Access Compliance Report

Public Rights-of-Way

| Intersection ID: 10039933 | Main Street: TRAVIS_GULCH_DR | Cross Street: N/A | Location: SW |
| ADA ID: 21A675E604A2 | Ramp Type: Perp | Initial Pass/Fail: Fail | Overall Compliance: No |

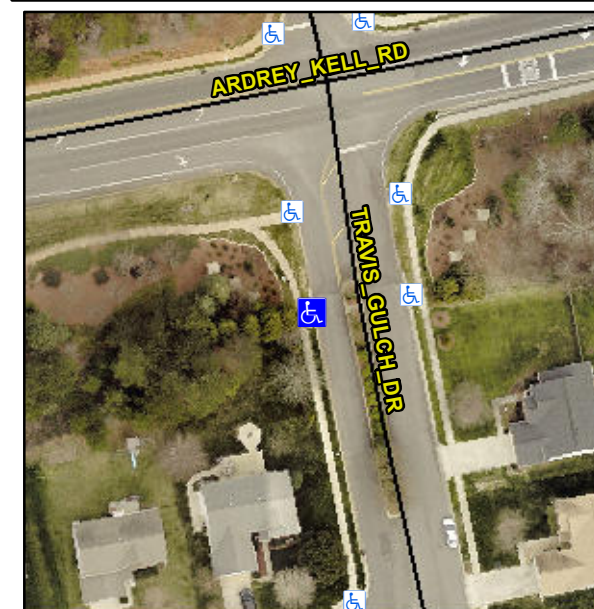
Not Found, R304.5.1, R304.5.3

| Compliance | Description | Data | Compliance | Description | Data |
|------------|-----------------------|------|------------|-----------------------------|------|
| N/A | Ramp Length (in) | 48.0 | Yes | Ramp Slope (%) | 5.8 |
| No | Ramp Width (in) | 47.0 | No | Ramp XSlope (%) | 3.9 |

Remove & Replace Entire Ramp.
